# REGIONAL REVIEW FINDING

ARC REVIEW CODE: R1410211

**Name of Proposal:** 3354 and 3356 Peachtree Road Development

**SUBJECT:** **Transportation Division Review of DRI # 2453**

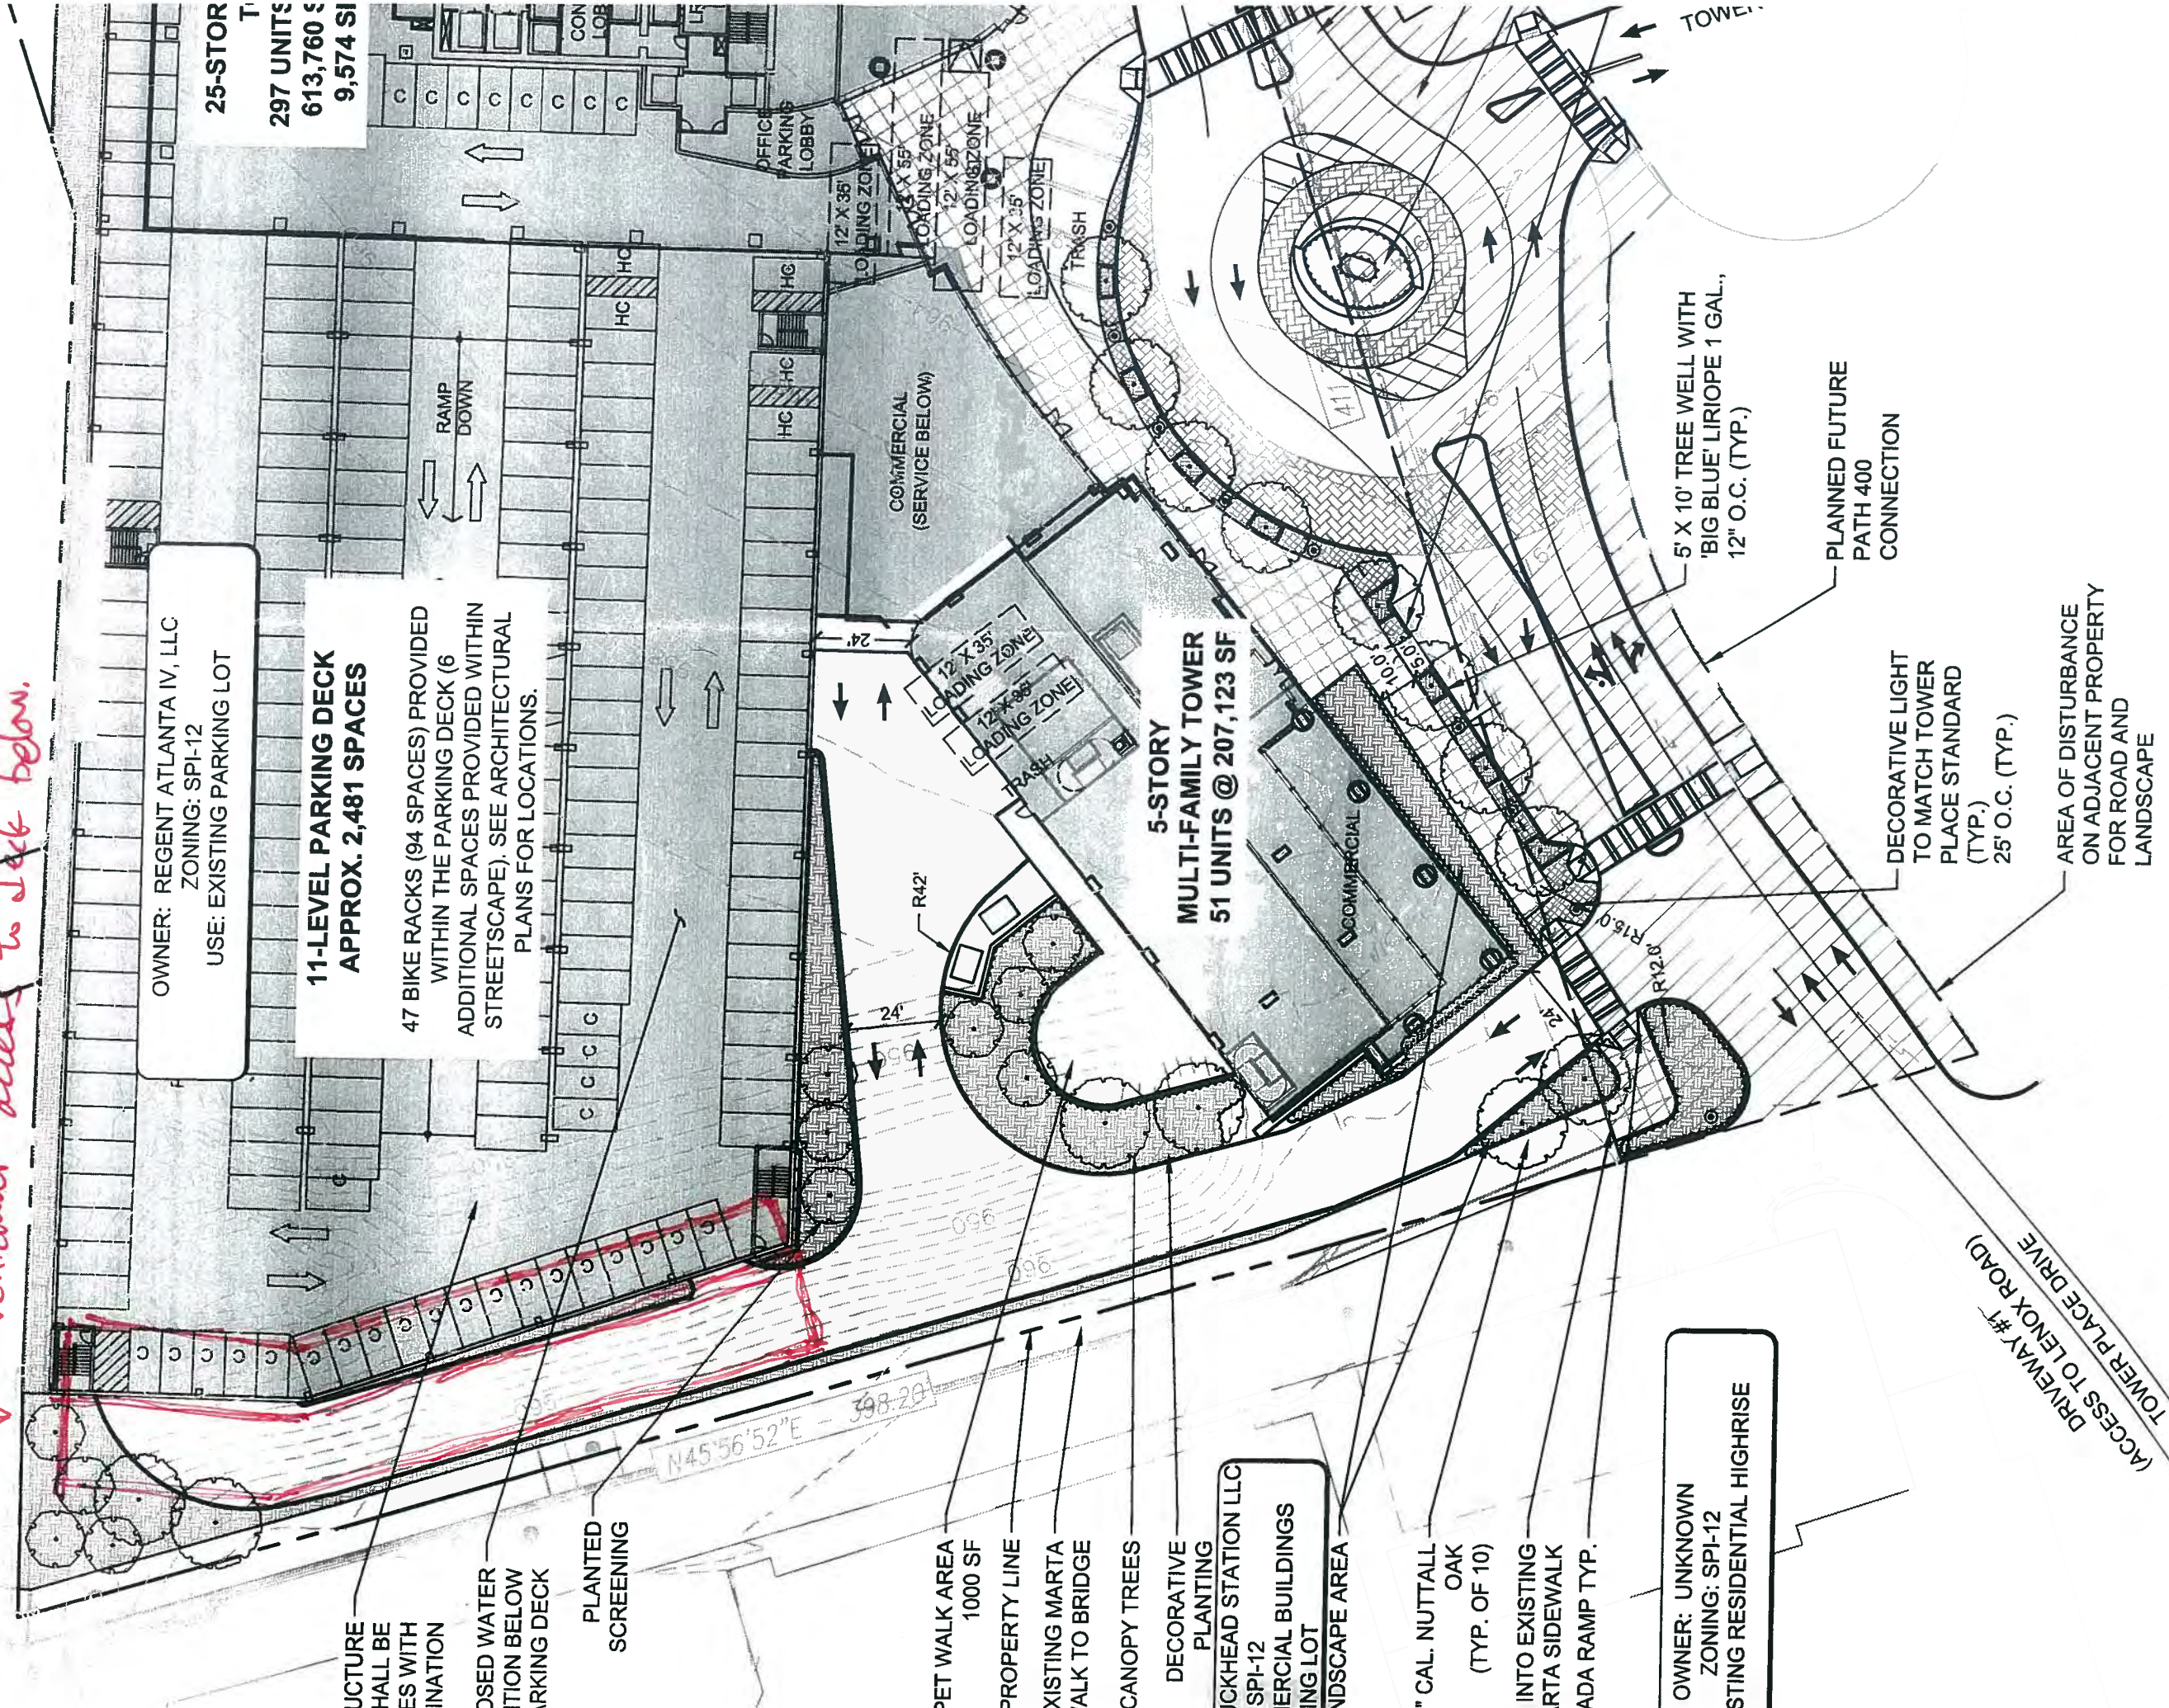
On behalf of the City of Atlanta, please find our recommended changes to the site plan and conditions for approval of the DRI. The letters below correspond to the letters in the attached diagrams.

- Line the 11-level parking deck with a minimum three-story residential or office building along the Buckhead MARTA Station connection. The lowest level of the liner building should be at or slightly above the level of the pedestrian connection to the Buckhead MARTA Station. Truck/loading access to the parking deck should be below the liner building. This will require moving the northwestern façade of the parking deck slightly to the southeast

- Redesign roundabout as shown in the attachment.
  - A. Northwestern-most curb cut should be truck/loading only
  - B. Add two crosswalks.
    - One directly connecting the MARTA access to the proposed PATH 400 trail.

- A second at the roundabout.
  - C. Remove the crosswalk shown near the northwestern-most curb cut.
  - D. Include bicycle gutter on staircase to upper level.

- E. Add a truck-mountable chicane to reduce vehicle speeds approaching the northwestern-most crosswalk.
  - F. Raise the northwestern-most curb cut as a speed table.

④ Include bicycle "gutter" on staircase

① Truck + Loading Only.  
No passenger vehicles.

⑧ Add crosswalk here

Y  
⑥ Remove this crosswalk

(E) Add truck-mountable chicane (F) Raise crosswalk; speed table

→ Add liner residential units, @ least 3 levels.  
Vehicular access to deck below.
